ADDENDUM 5

DATE: June 16, 2016

PROJECT NAME: NAVAJO TRIBAL UTILITY AUTHORITY WASTEWATER TREATMENT PLANT UPGRADES

PROJECT NO. 115111

CIVIL
JUNCTION BOX 7

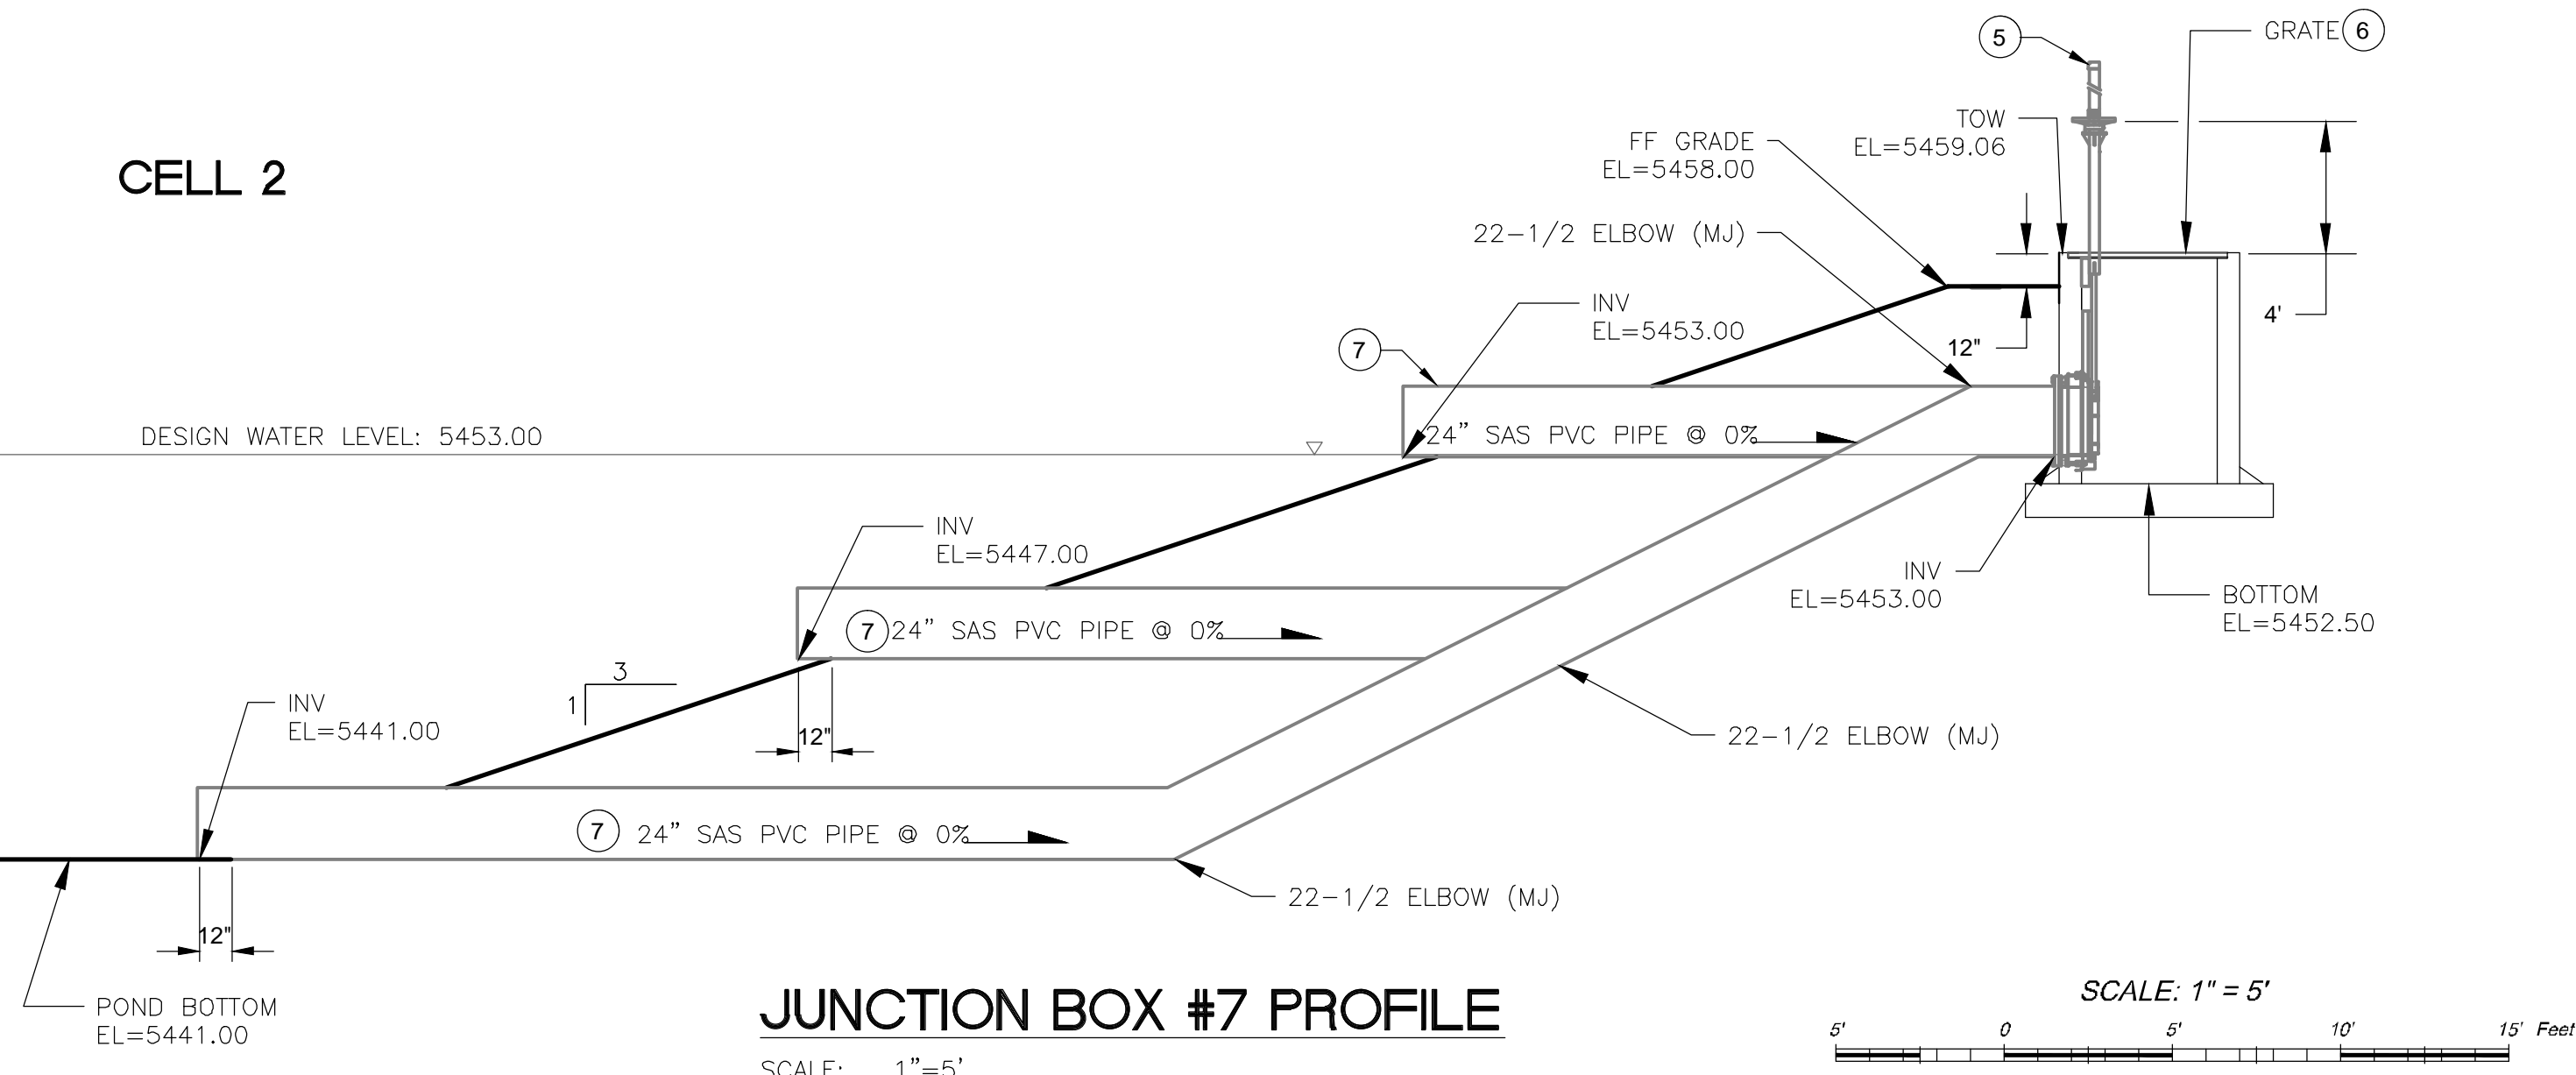
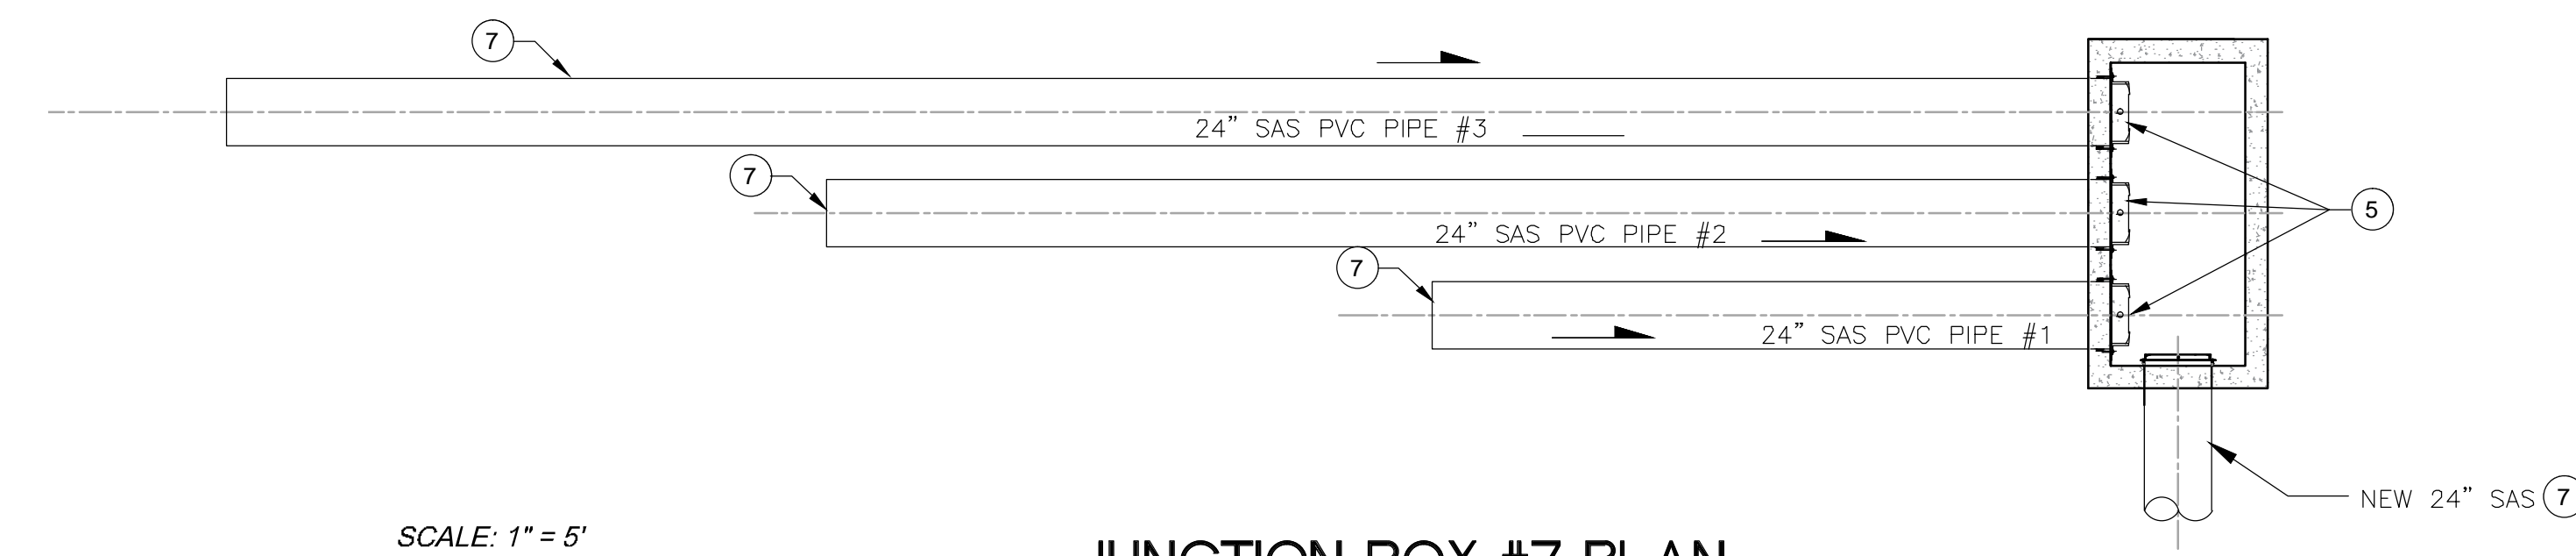
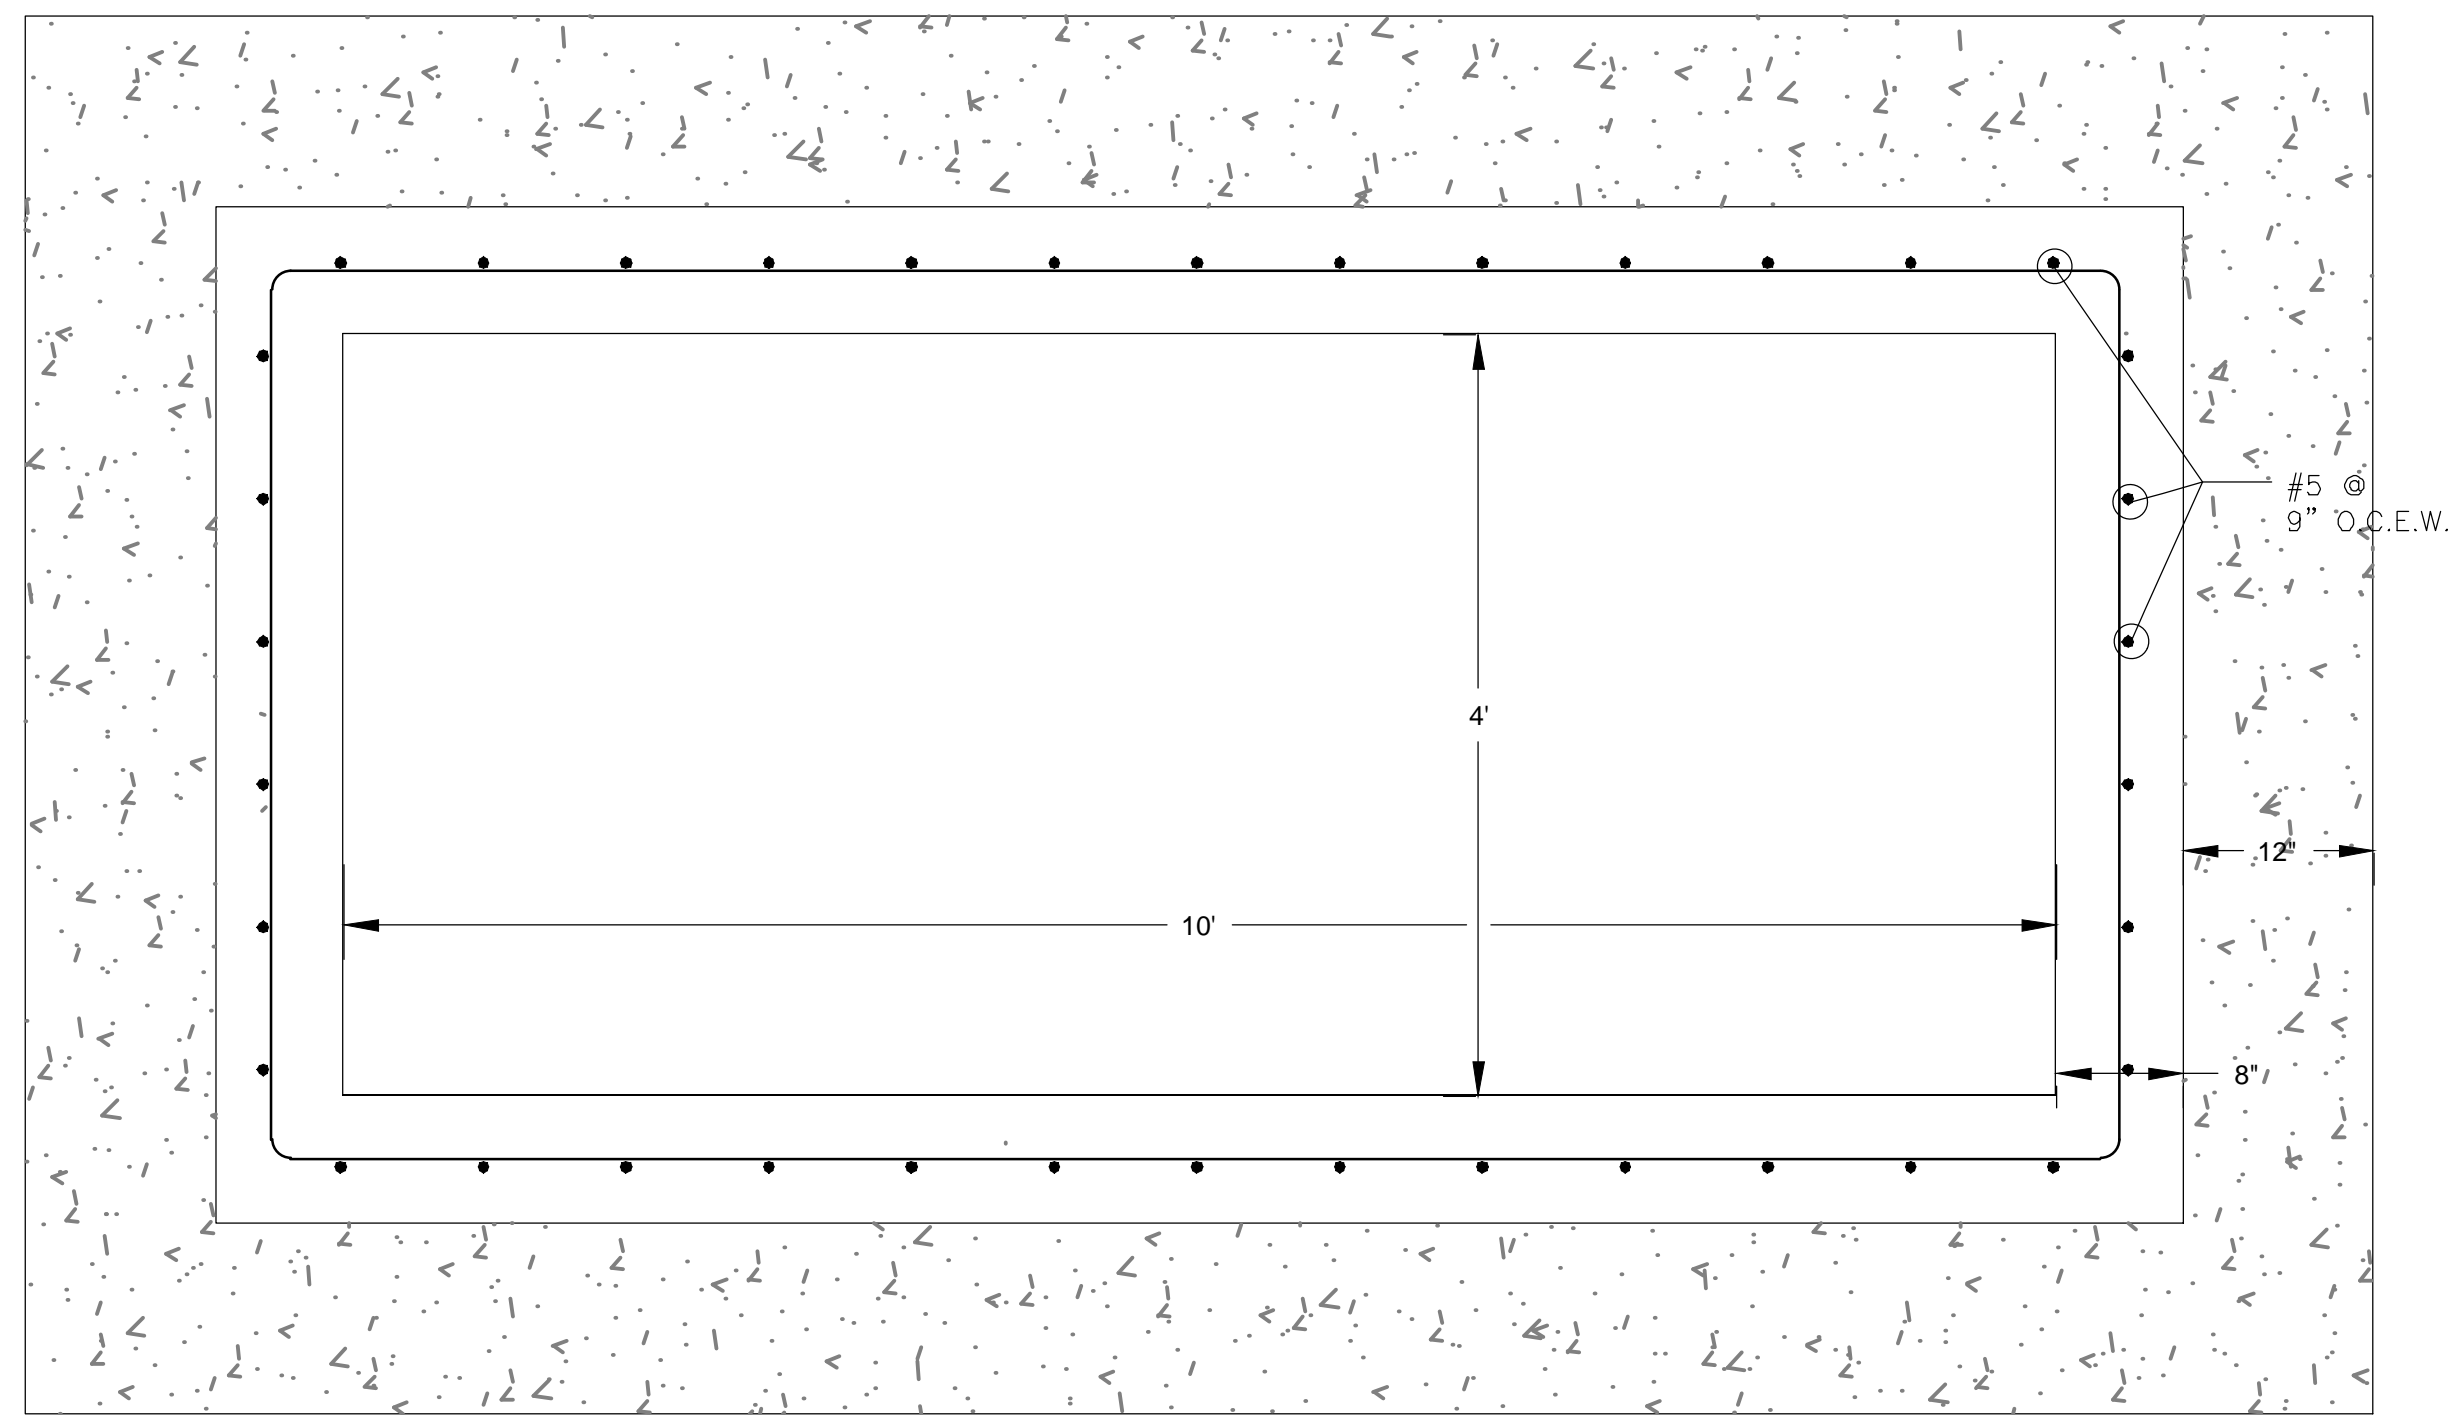
6. **Question:** Regarding Supplemental Specifications section 31 55 00 – Earth Retention, where does this apply? The only structure that we see that may need something is the new junction box at Chinle between dells 2 and 4. If cell 4 has water in it that will be a problem to dig that deep (20' below existing ground). Soil nails don't look like the right application for this

1. **VOLUME 2.1 CHINLE WWTP:** REMOVE sheet 16 and 17 dated April 2016 and REPLACE with the attached sheet 16 and 17 dated June 2016.

- 1 STRUCTURAL CONCRETE: FURNISH AND INSTALL REINFORCED PORTLAND CEMENT CONCRETE PER STRUCTURAL SHEETS, COMPLETE AND IN PLACE.
- 2 SUBGRADE PREP: PREPARE SUBGRADE FOR STRUCTURES INCLUDES EXCAVATION (3FT BELOW BOTTOM FOUNDATION ELEV.) AND COMPACT PER STS 31 20 00, COMPLETE.
- 3 STRUCTURAL FILL: FILL CONSTRUCTION FOR STRUCTURES INCLUDING PLACEMENT AND COMPACTION OF SUITABLE ENGINEERED FILL MATERIAL (STS 31 20 00) AND REINFORCING GEOGRID (STS 31 05 19) , COMPLETE.
- 4 EXCAVATE AND SPOIL UNSUITABLE MATERIAL PER STD SPEC 206, COMPLETE.
- 5 FURNISH AND INSTALL SLUICE GATE PER SUPPLEMENTAL SPECIFICATION 35 20 16, COMPLETE AND IN PLACE.
- 6 FURNISH AND INSTALL GRATE PER SUPPLEMENTAL SPECIFICATION 05 53 13 , COMPLETE AND IN PLACE.
- 7 FURNISH AND INSTALL 24-INCH SDR SAS PIPING INCLUDING FITTINGS, TRENCHING, COMPACTION, COMPLETE AND IN PLACE.

Response: Please see the modifications to the bid documents below. These modifications should eliminate the need for earthwork retention for junction box 7.
